**Re: CDS22003279 pre-connection enquiry - Subject to contract | Contract denied**

**Connection for Multi/Mixed Use Development of 634 units at Emmet Road, Inchicore, Dublin**

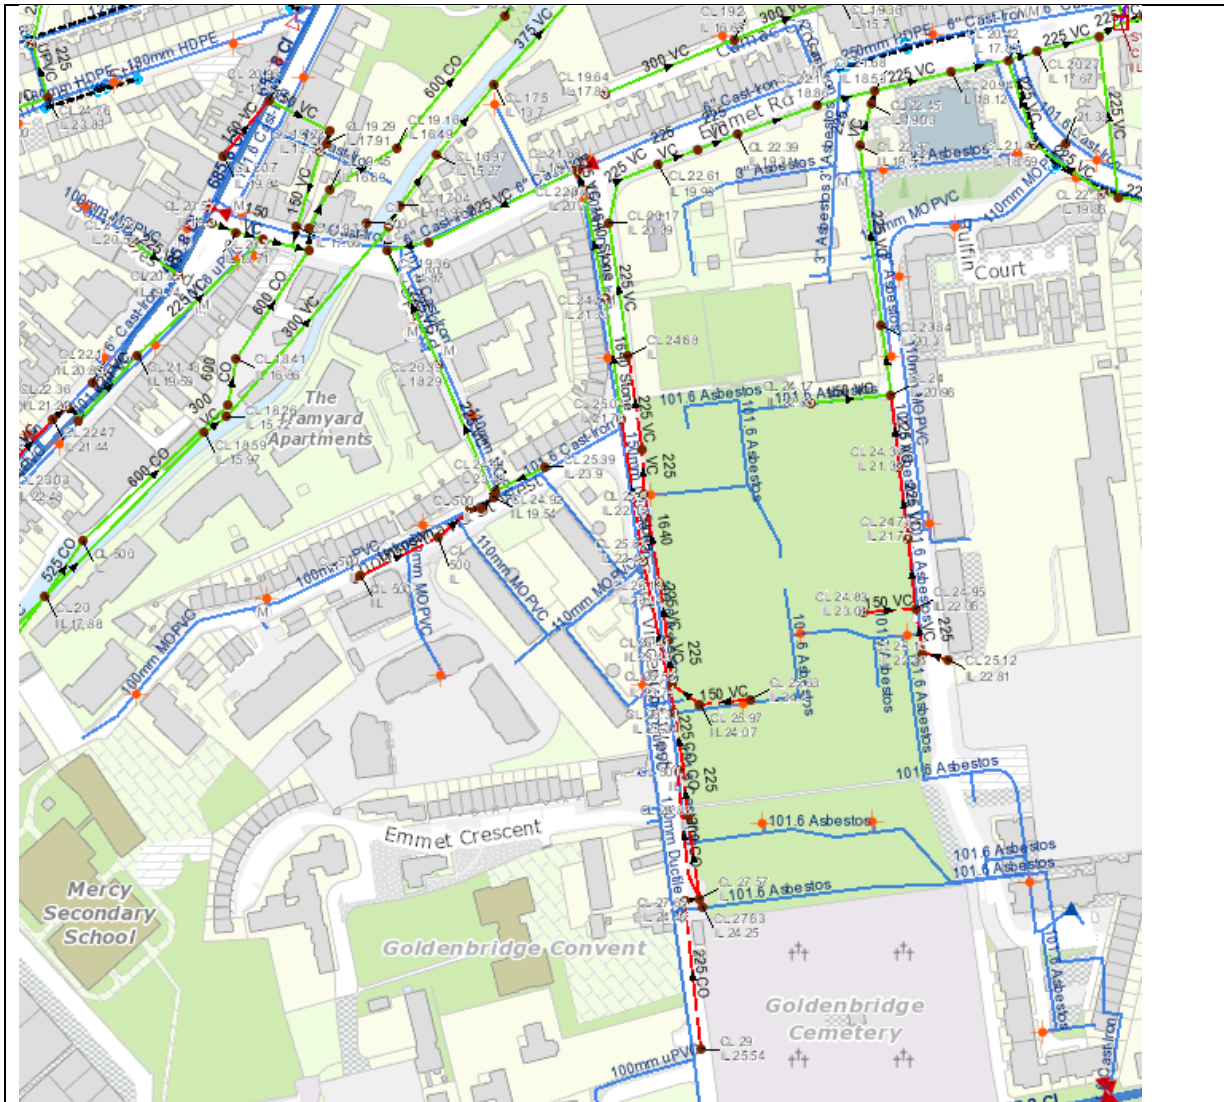
SERVICE	<p align="center"><b>OUTCOME OF PRE-CONNECTION ENQUIRY</b></p> <p align="center"><b><u>THIS IS NOT A CONNECTION OFFER. YOU MUST APPLY FOR A CONNECTION(S) TO THE IRISH WATER NETWORK(S) IF YOU WISH TO PROCEED.</u></b></p>
Water Connection	Feasible Subject to upgrades
Wastewater Connection	Feasible without infrastructure upgrade by Irish Water
<b>SITE SPECIFIC COMMENTS</b>	
Water Connection	<p>In order to accommodate the proposed connection, upgrade of the existing 6" main to a 200mm ID pipe in Emmet Road for approximately 180mm (including bridge crossing) will be required. The water main section is highlighted in red below.</p>

Connection main should be also a 200 mm ID pipe connected to the new 200mm ID main. A DMA meter is to be installed on the connection main and linked to telemetry online.
